PROPOSED SITE IMPROVEMENTS
186 GROVE STREET, FRANKLIN, MA

**Re: 186 Grove Street
Site Plan Peer Review**

RE: Site Plan Modification Review – 186 Grove St

DATE: December 2, 2020
TO: Franklin Planning Board
FROM: Department of Planning and Community Development
RE: 186 Grove Street
Site Plan Modification

1 LEACHING BASIN DETAIL
NOT TO SCALE

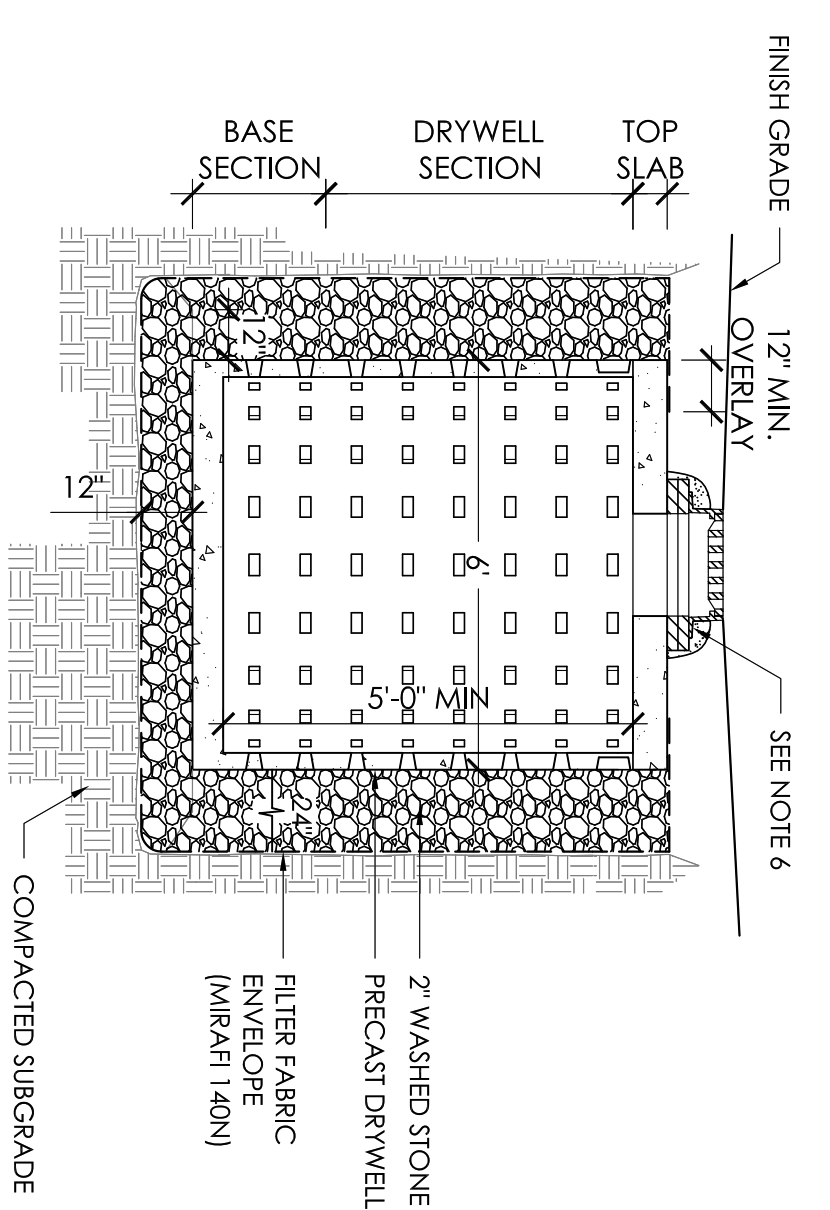
- SW1. Clarify if a pipe connection (recommended) is proposed between the two leaching basins.

1. We recommend making a piped connection between the existing and proposed leaching basin in addition to connecting the stone beds rather than relying on the stone beds alone for transmission of the stormwater between basins.

2 HAYBALE & SILT FENCE DETAIL
NOT TO SCALE

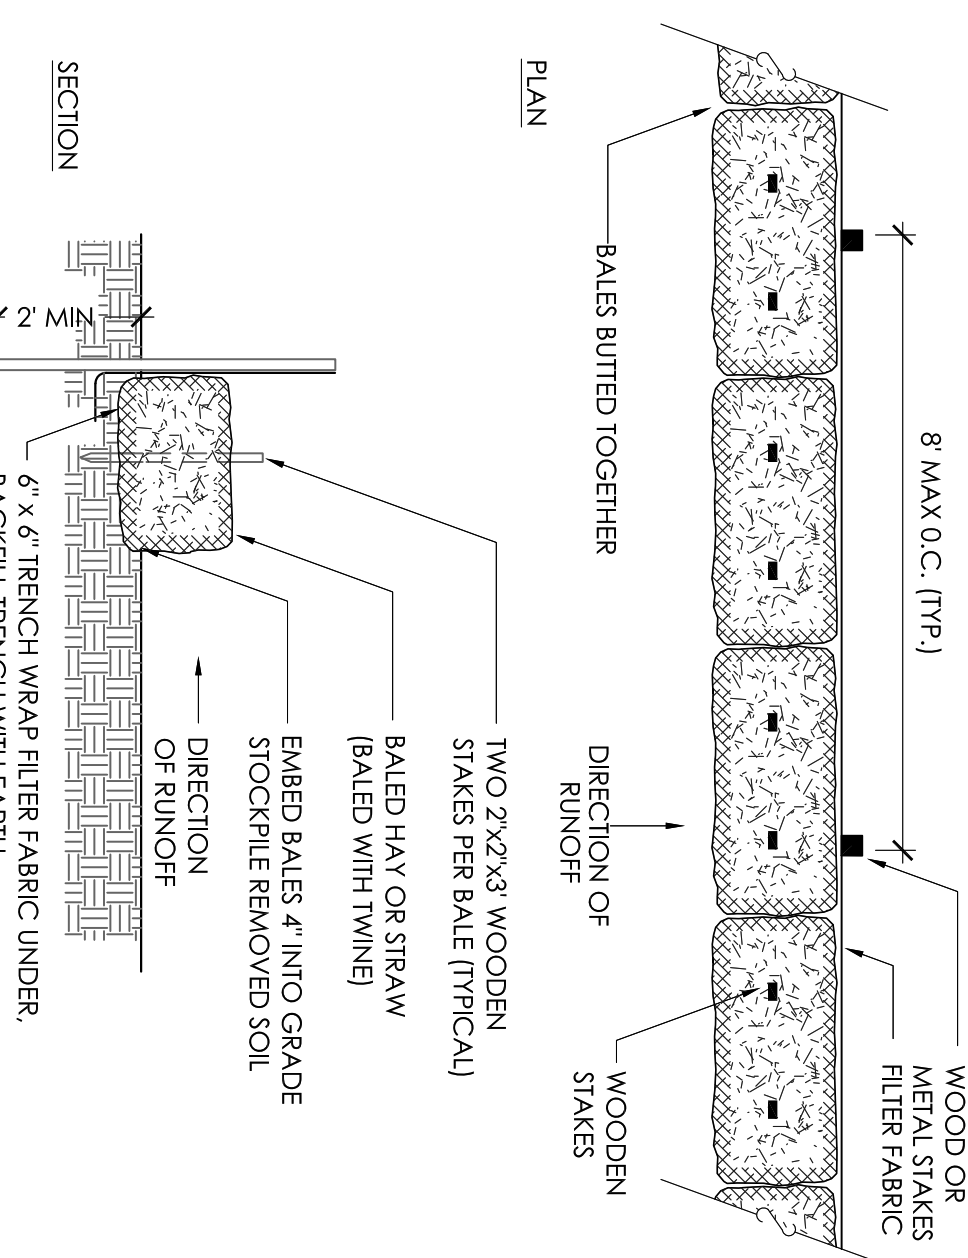
SW5. Revise Haybale & Silt Fence Detail to an appropriate alternative, such as straw wattles or compost filter tube. Hay bales and silt fence are not permitted by the Conservation Commission.

3 TYPICAL PARKING LOT LIGHT POLE
NOT TO SCALE

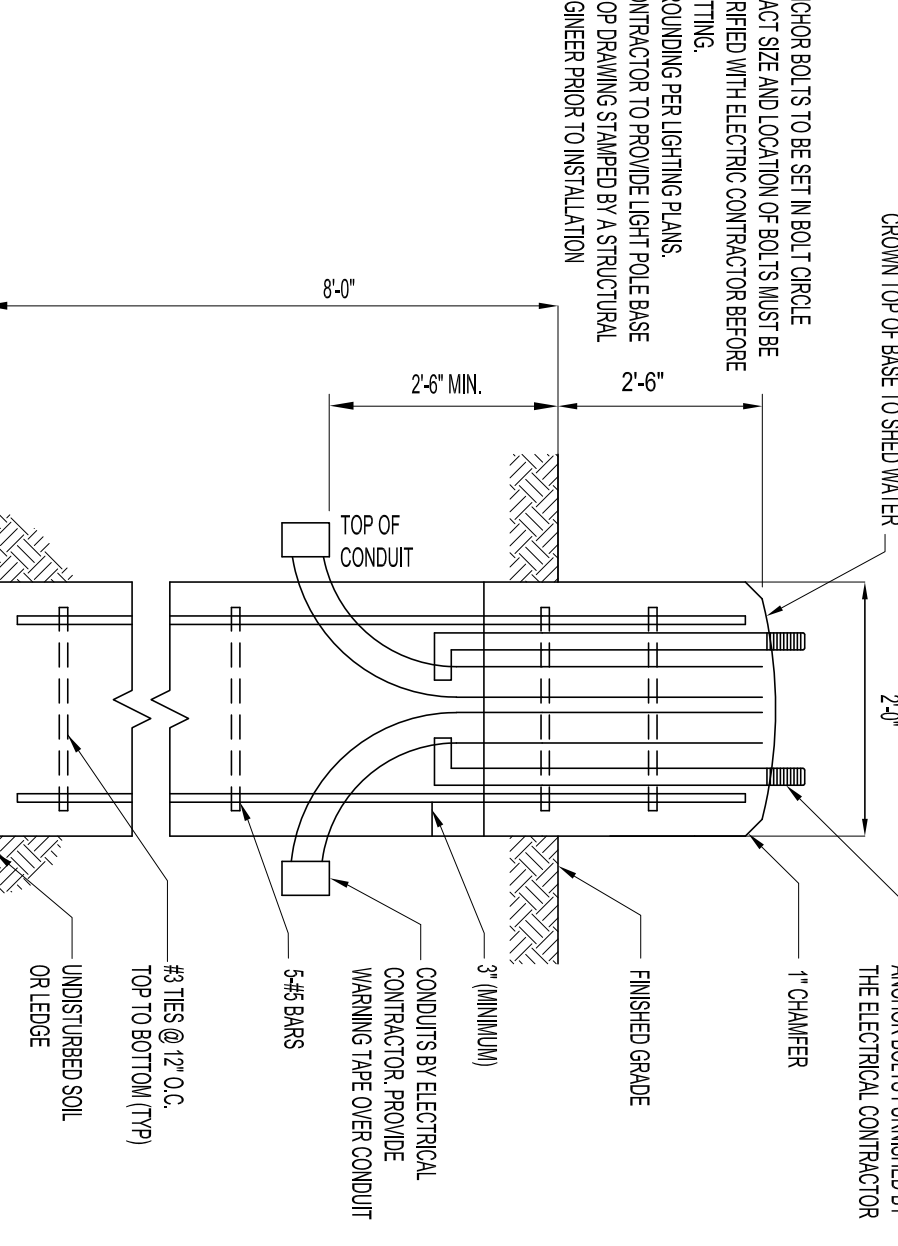
- SP2. Recommend revising the Typical Parking Lot Light Pole Detail to indicate a height that matches the installed light (~15 feet).

4 DUMPSTER ENCLOSURE - SECTIONS
NOT TO SCALE

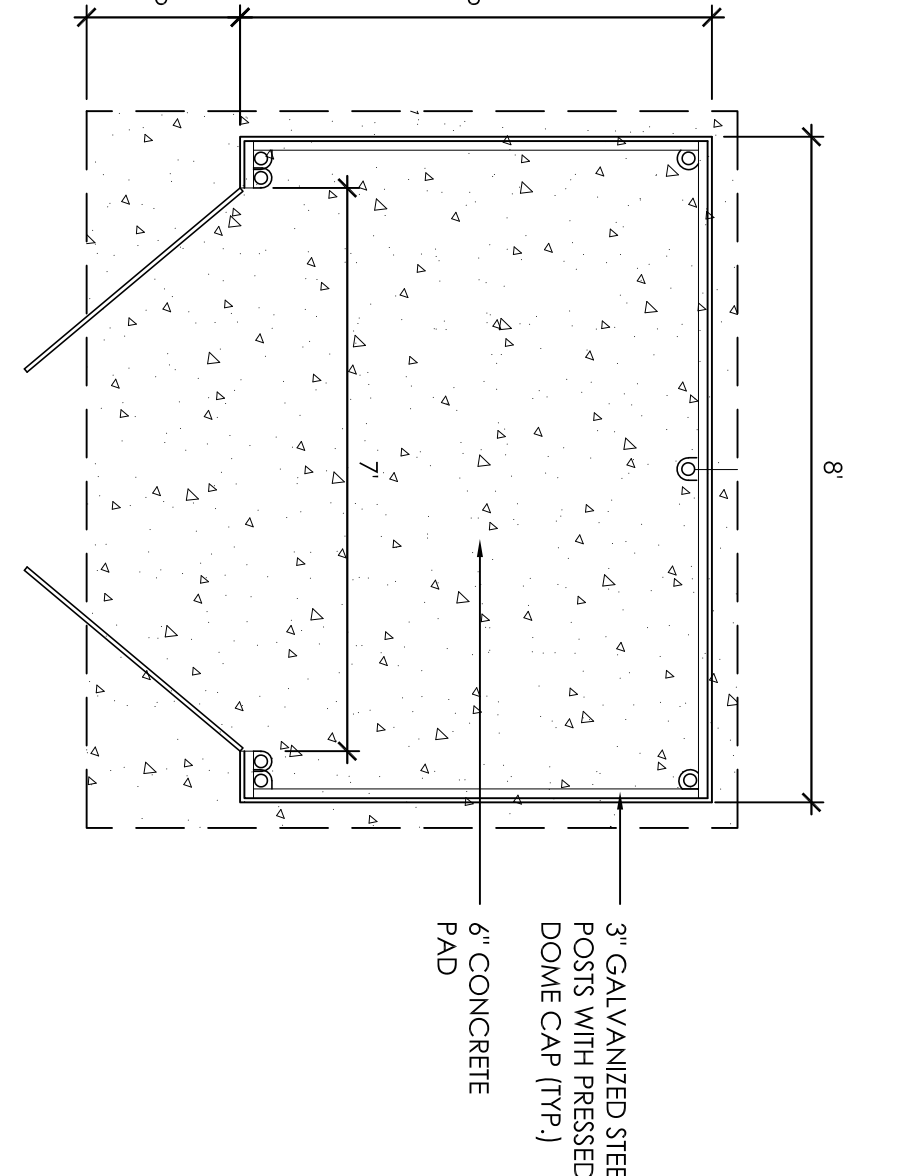
- WS1. The Dumpster Enclosure Section detail indicates a proposed enclosure height of 3'-6" where Town Bylaws (§218-2) typically require a height that is 3 feet above the top of lid. BETA notes, however, that 6' high enclosures are typically acceptable to the Planning Board.
- WS2. Recommend providing reinforcement for the concrete dumpster pad.
